Mary Kay, Inc.
 Corporate 1
 Addison, Texas
 Cooling Tower Addition

COOLING TOWER ADDITION

PLEASE REVIEW THESE CHECK
PRINTS W/NEXT SUBMITTAL

Project Revisions
 ▲ ADDENDUM 1 08/06/03

C.01

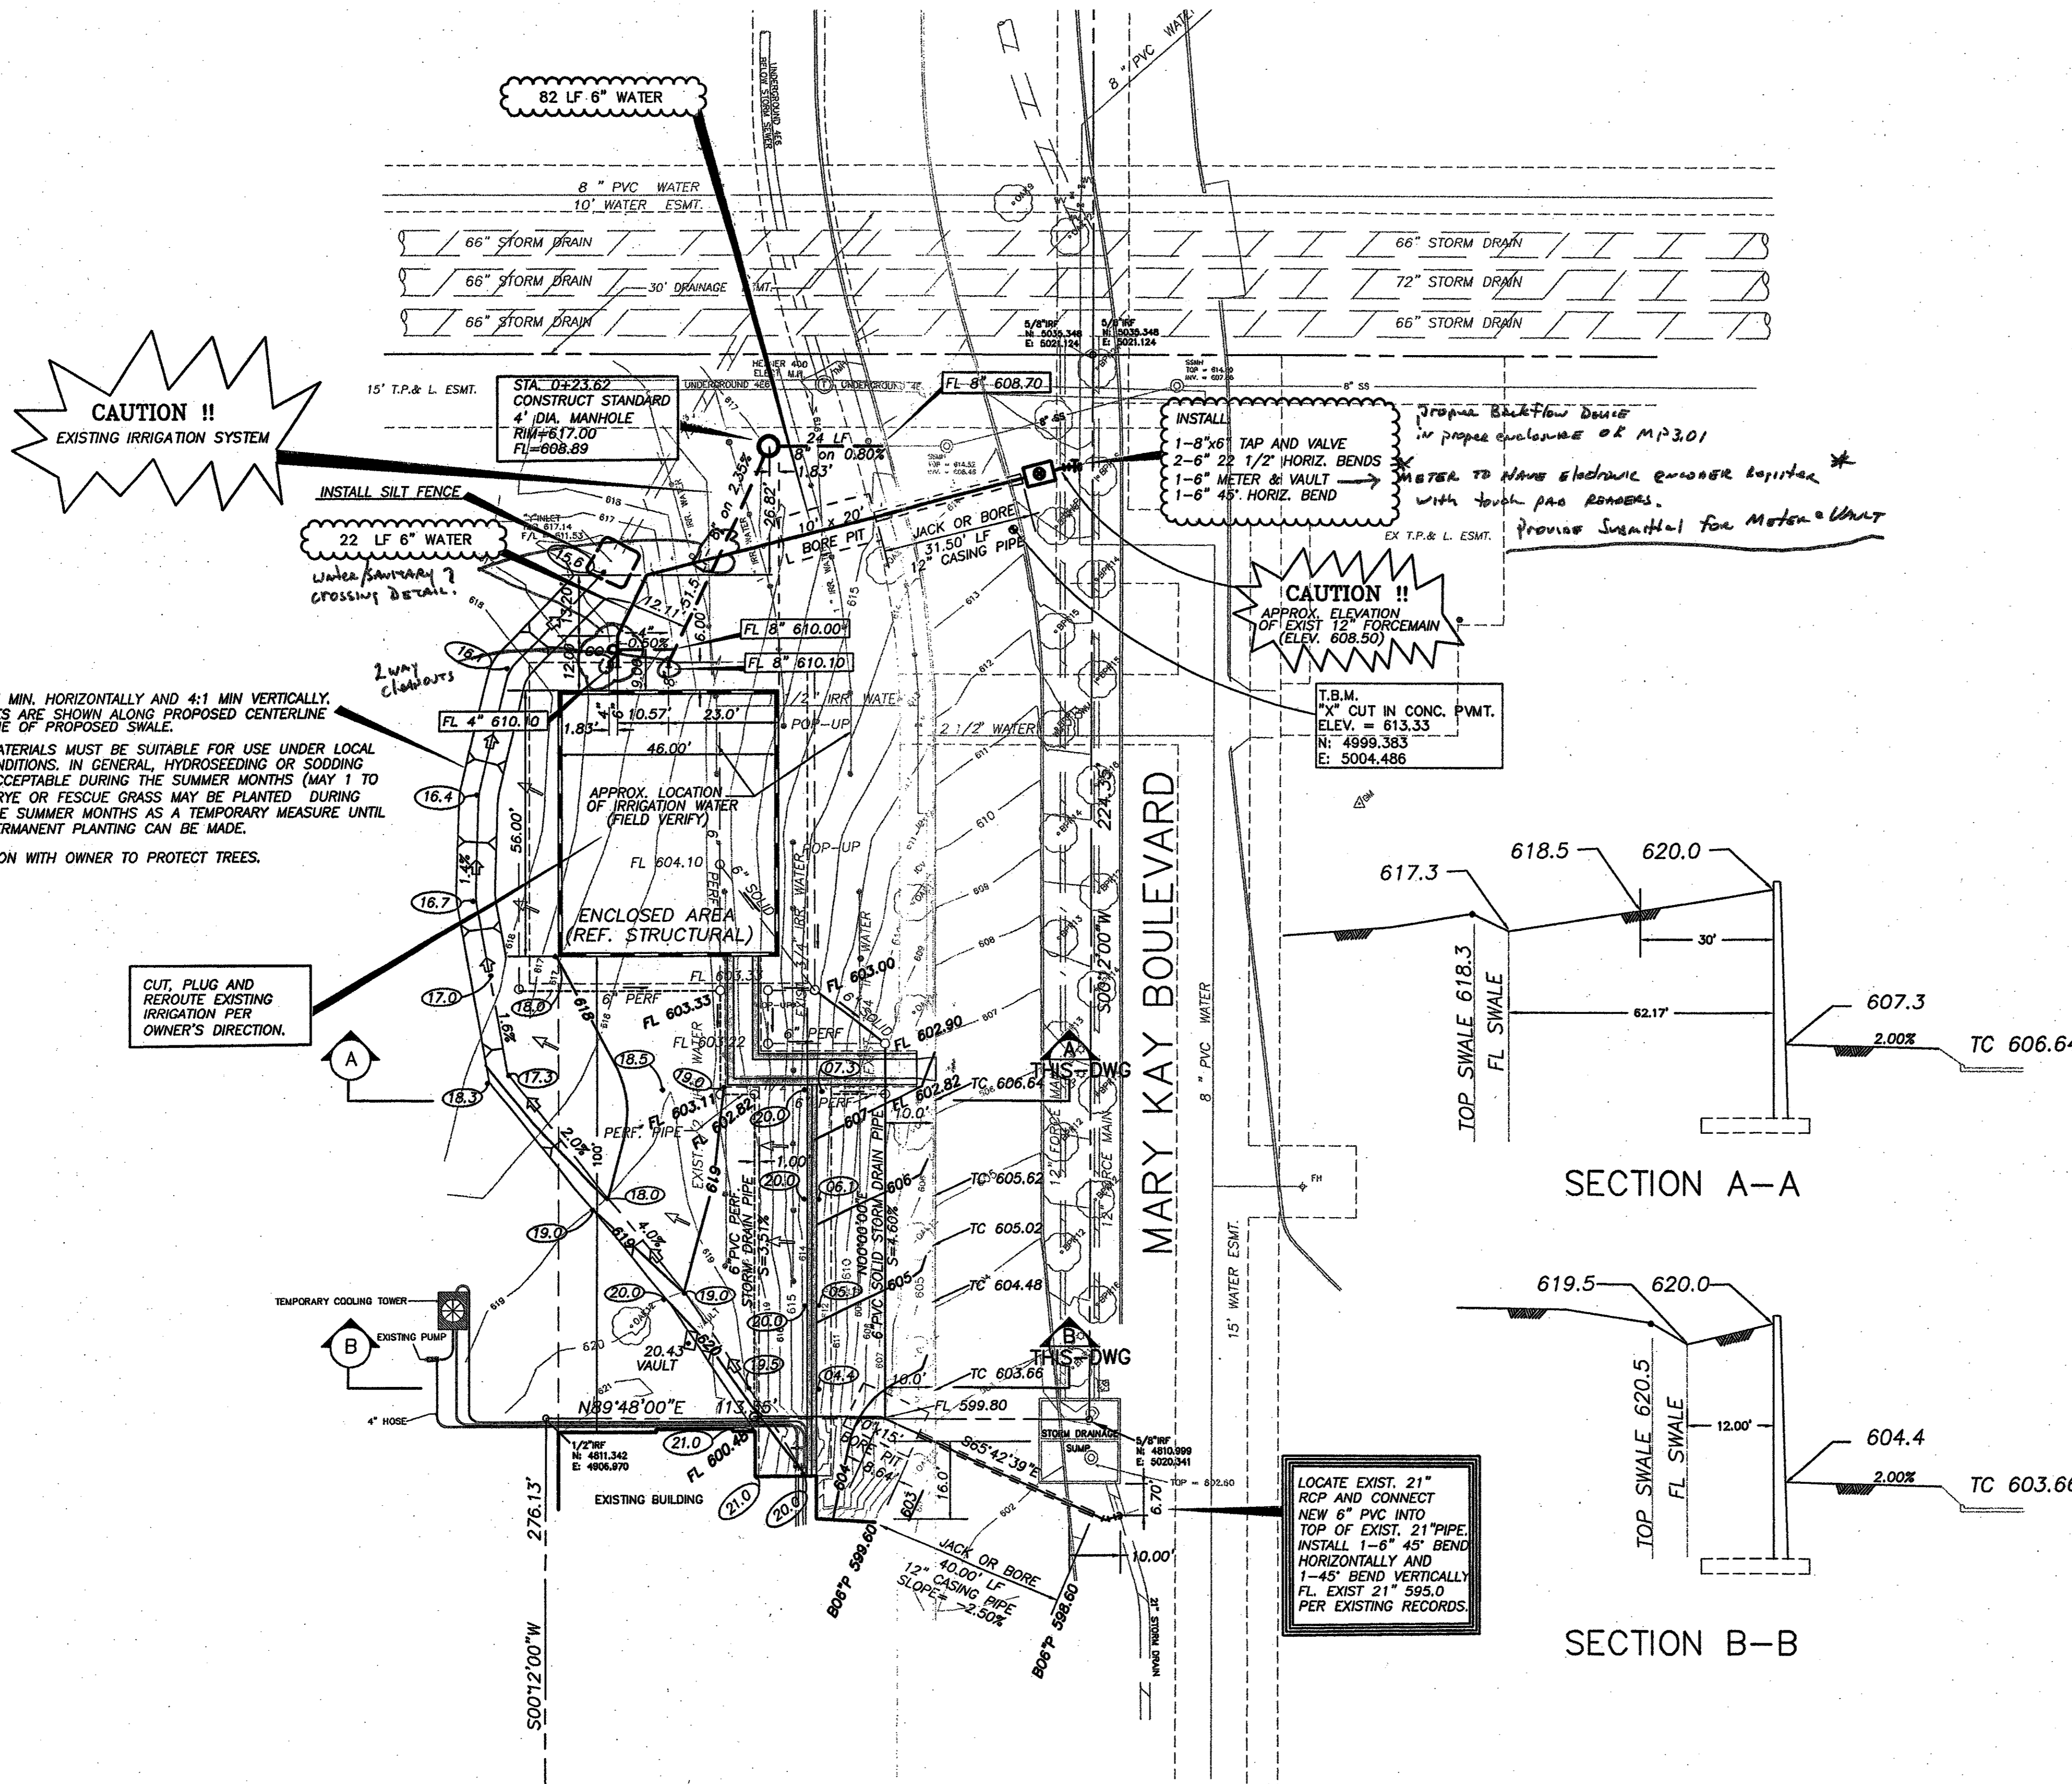
- A. ON SHEET C-01, NOTE THAT THE TREE LOCATED NORTH OF THE EXISTING BUILDING, ALONG THE 620' CONTOUR LINE, ADJACENT THE TEMPORARY COOLING TOWER, SHALL REMAIN IN PLACE WITH ADEQUATE ROOT PROTECTION DURING EXCAVATION AS REQUIRED IN THE ADD ALTERNATE NO. 1 WORK. CONTRACTOR'S OPTION: THE SUBJECT TREE MAY BE REMOVED, STORED ON SITE, PROTECTED AND REPLANTED PROVIDED IT IS REMOVED BY AN APPROVED METHOD AND REPLACED WITH LIKE KIND AND SIZE IF DAMAGED.
